3RD ST. E.L. PINECREST to W.L. HARDING AVE. 30' INT. CO. & G.

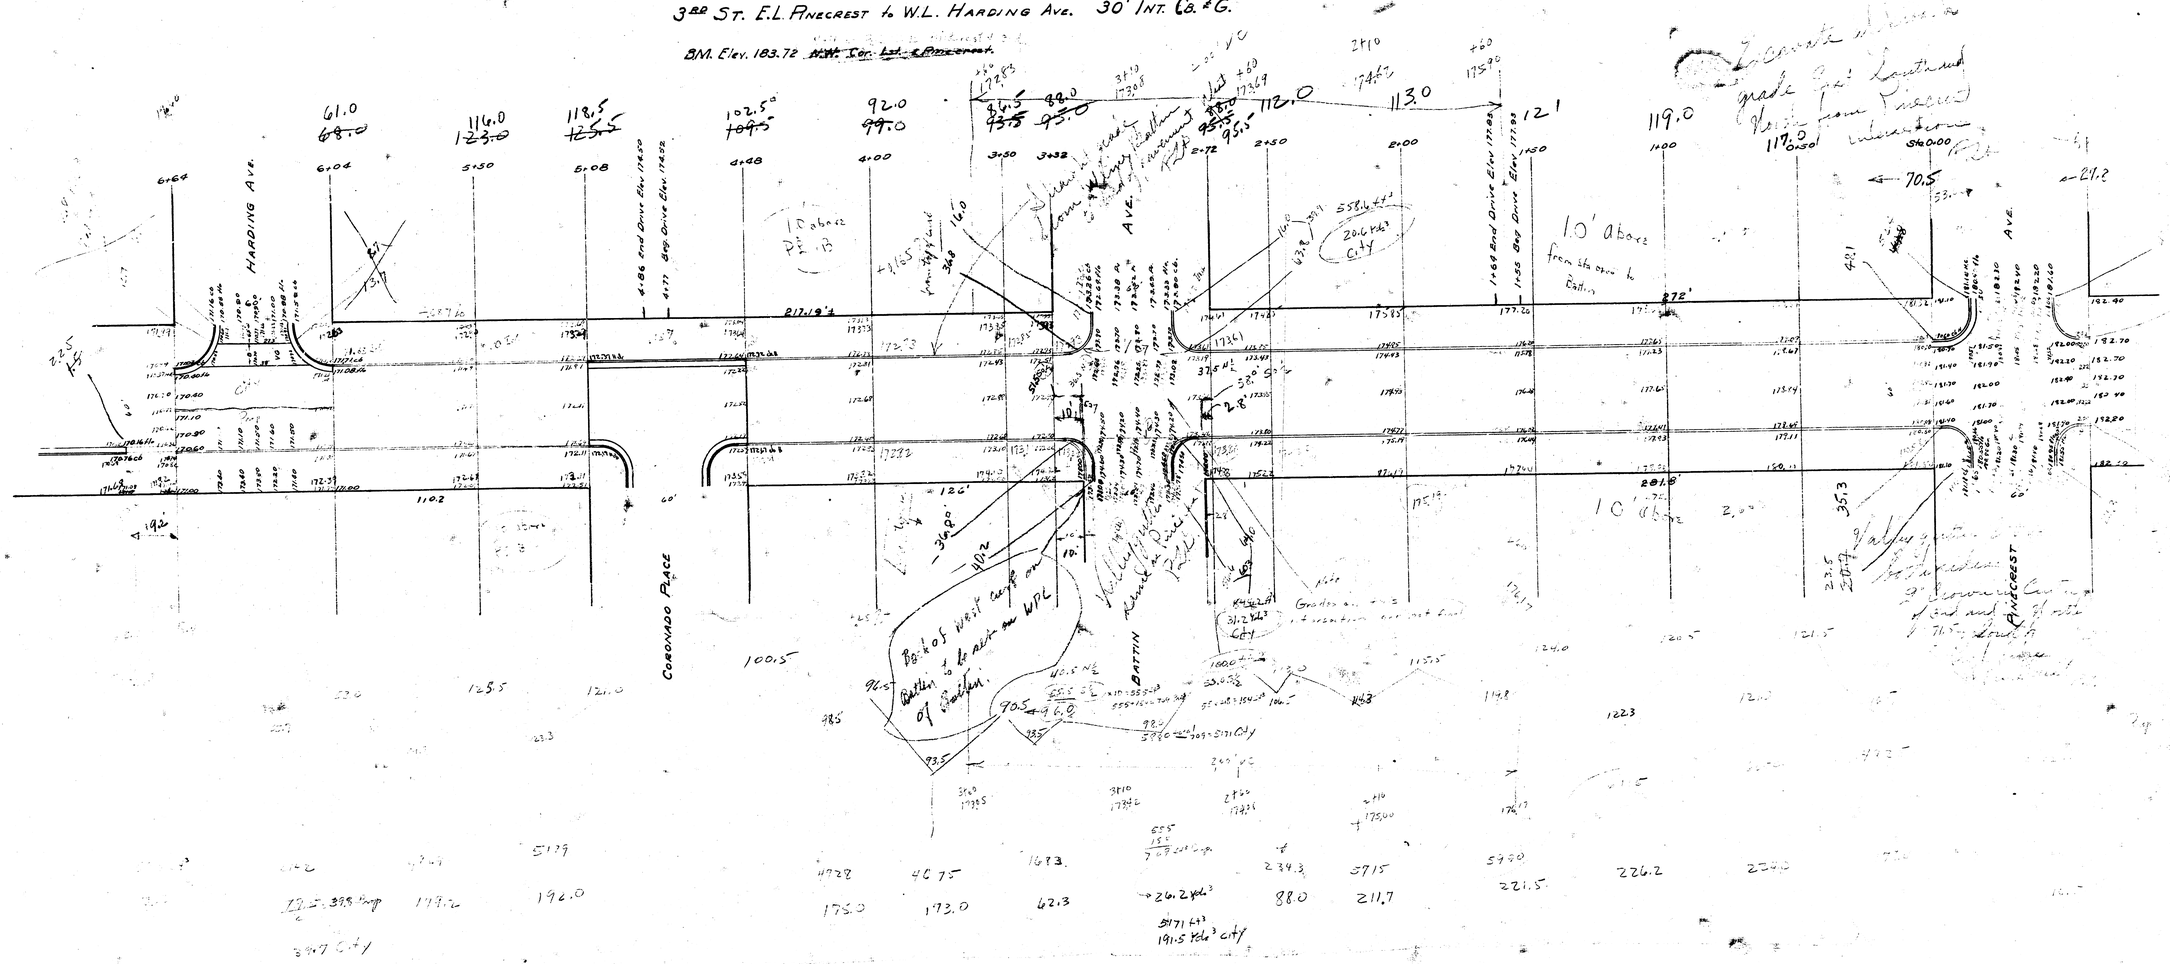
BM. Elev. 183.72 ~~A.W. Ior. Ld. Pinecrest.~~

HARDING AVE.
CORONADO PLACE
BATTIN
AVE.
PINECREST
AVE.
Locate at least 1' above grade for Southward flow from Pinecrest Intersection
1.0' above from the grade to Battin
10' above P.I. 13
Bk of west curb on WPL Battin to be at same elev. of Pinecrest.
Gradient from Pinecrest
Grade at this point to be 1' above grade at Pinecrest
Valley gutter to be at same grade as Pinecrest
Grade at this point to be 1' above grade at Pinecrest
Top of curb to be at same grade as Pinecrest
Top of curb to be at same grade as Pinecrest
Top of curb to be at same grade as
